ADDENDUM NO. 1

Reference: Fire Suppression System Replacement – West Jordan AASF
Utah National Guard – West Jordan, Utah
DFCM Project No. 09022480

Project: 09022480 – AASF South Hangar Fire Protection Upgrade

Subject: Addendum #1

FP-5

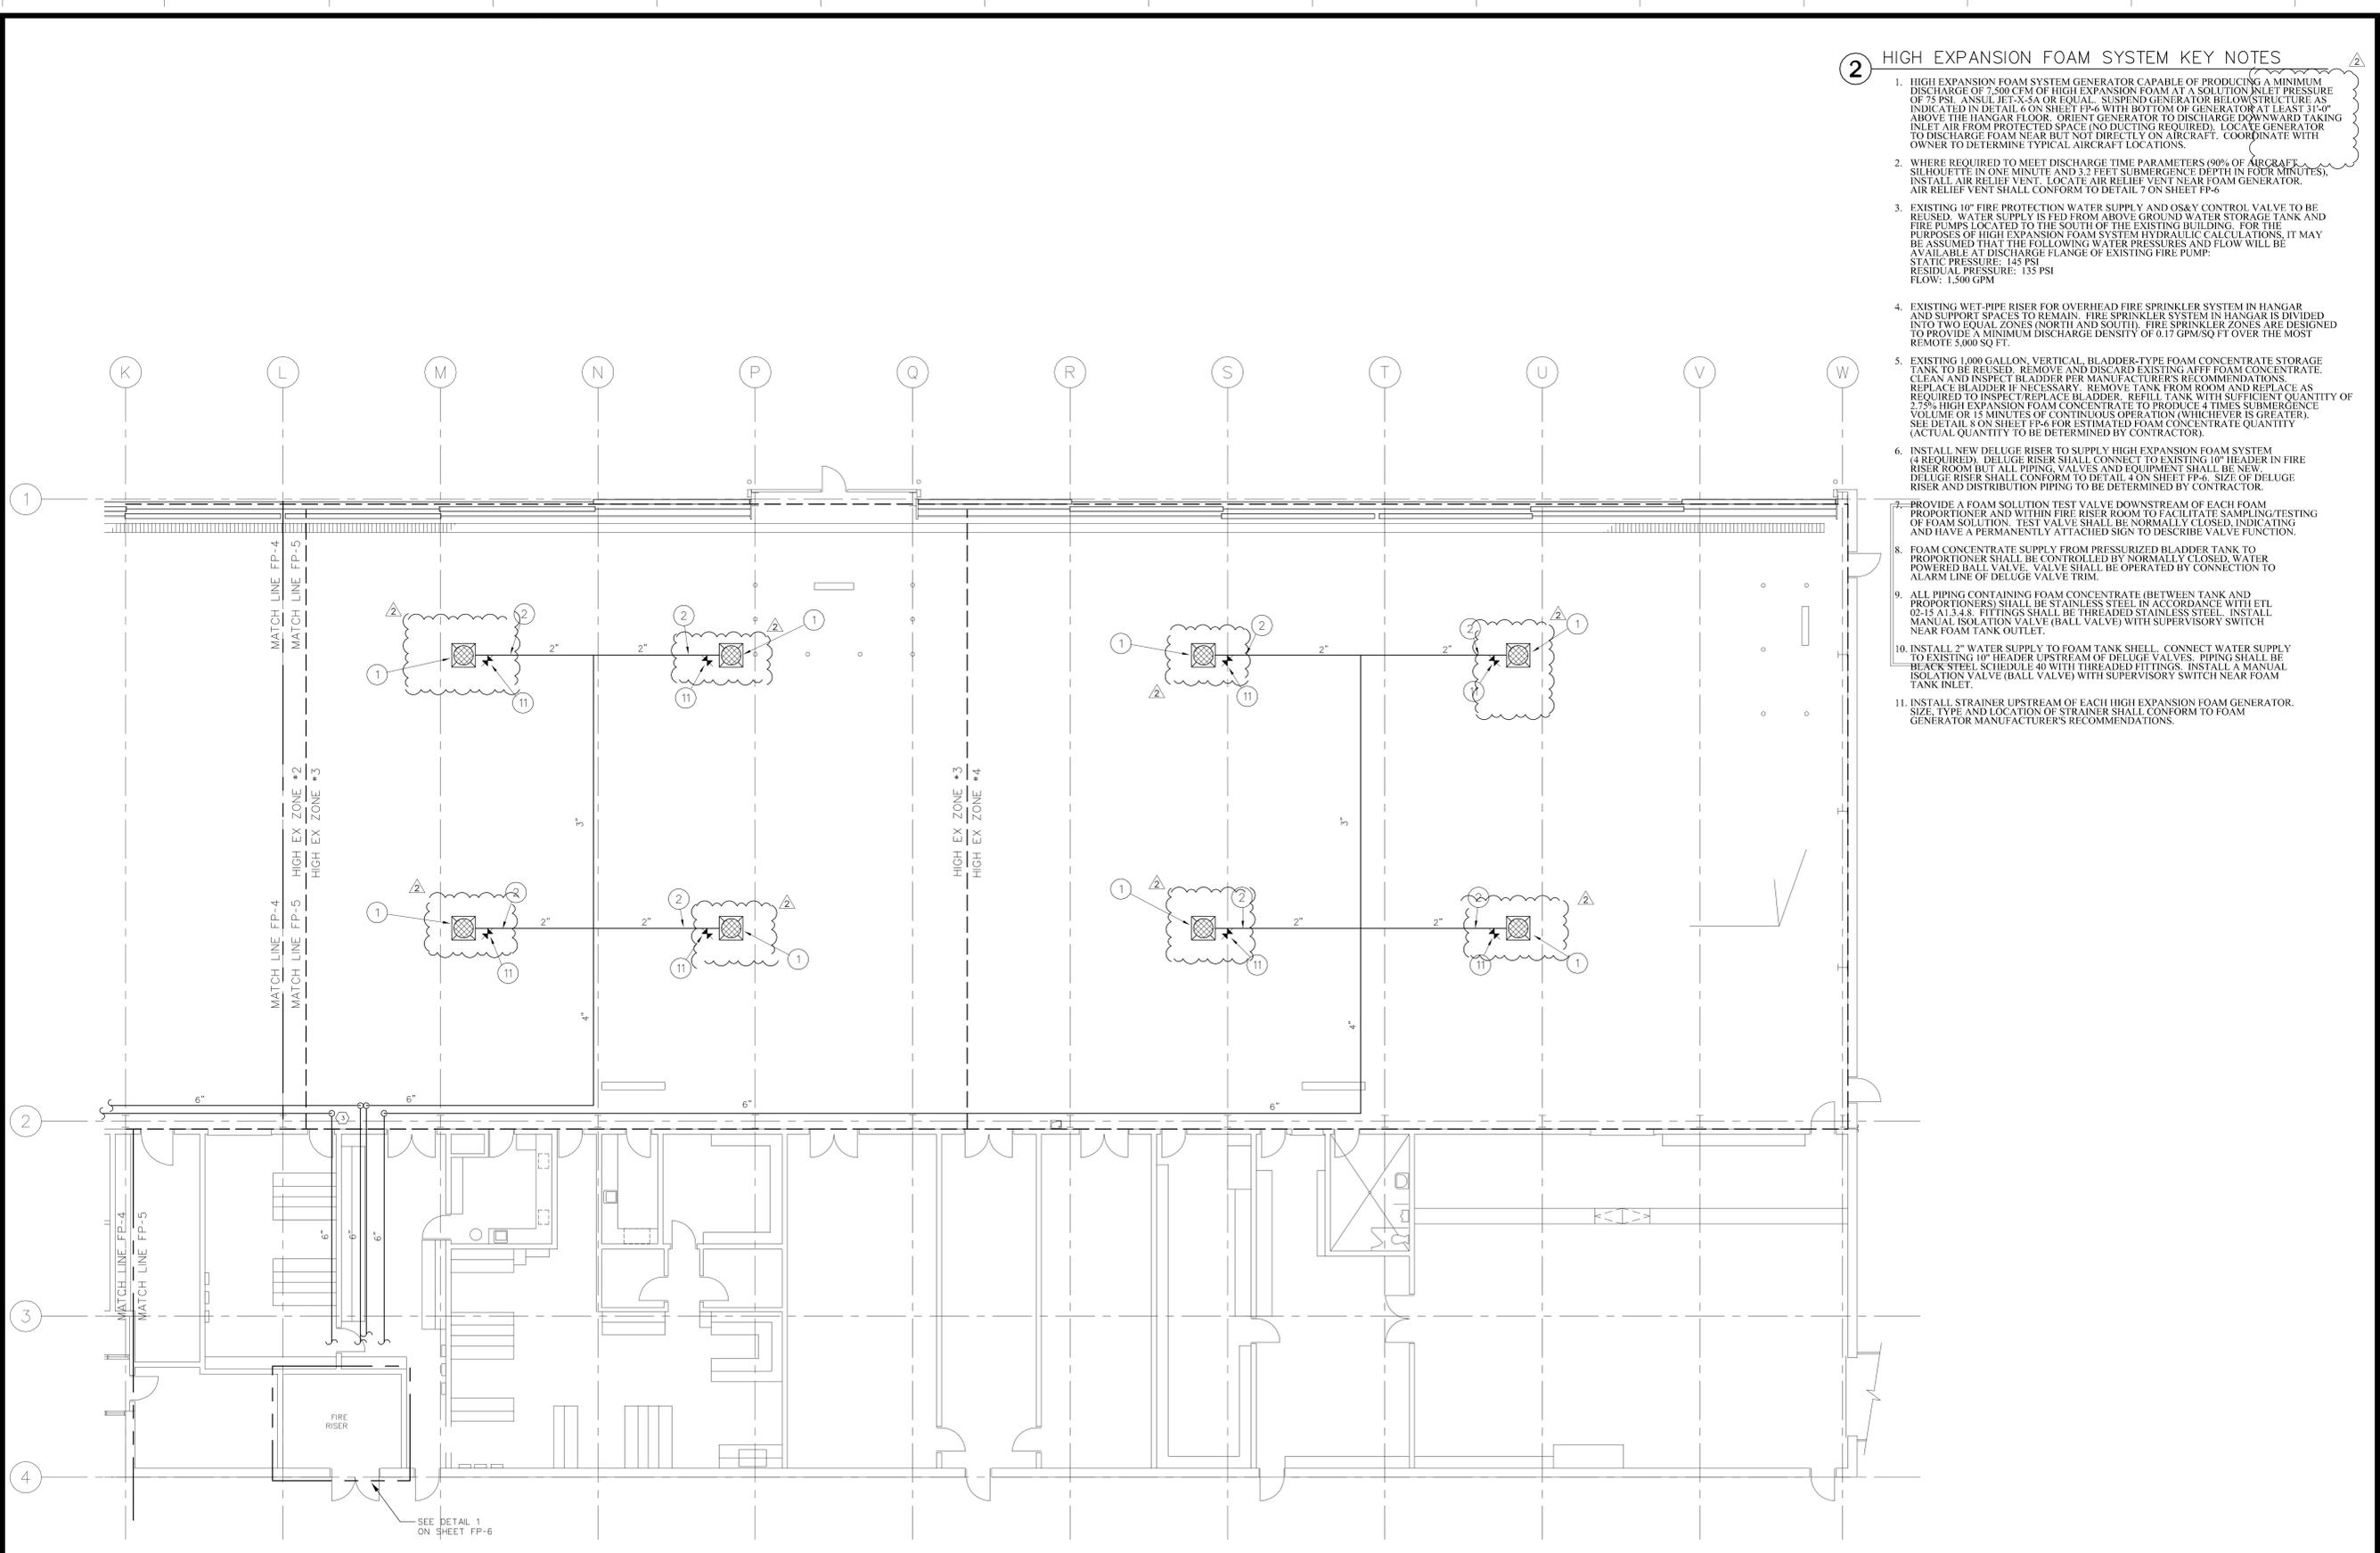
V. Drawing Revisions Sheet FP5

1. Relocated high expansion foam generators to better coordinate with aircraft locations.
2. Edited key note 1 to specify a minimum mounting height of 31’-0” to the bottom of the foam generator as required to avoid conflicts with bridge crane.

4 DELUGE RISER SCHEMATIC
NO SCALE

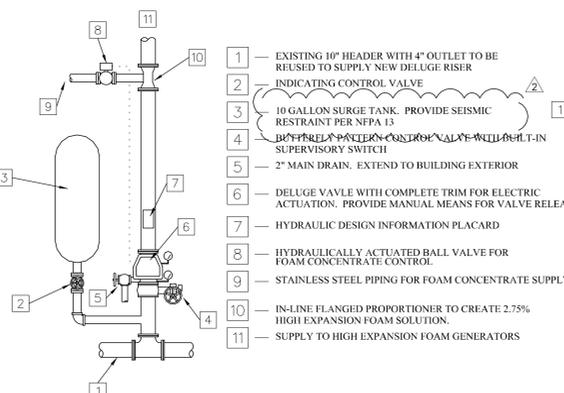
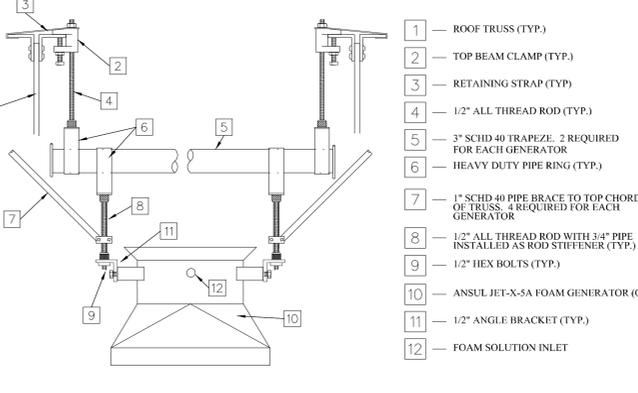
VI. Drawing Revisions Sheet FP6

1. Revised call out note 3 on detail 4 to require seismic restraint of surge tanks.

Question 1: Surge tanks are indicated for each deluge riser by call out note 3 on detail 4 of sheet FP-6. Will the tanks be required to be UL Listed?

Question 2: Are seismic restraints required for the surge tanks?

Response: Yes. In accordance with general note 4 on sheet FP-6 all fire protection system components must be UL Listed or FM Approved for use in fire protection systems.

Response: Yes. See revision to sheet FP-6 indicated above.
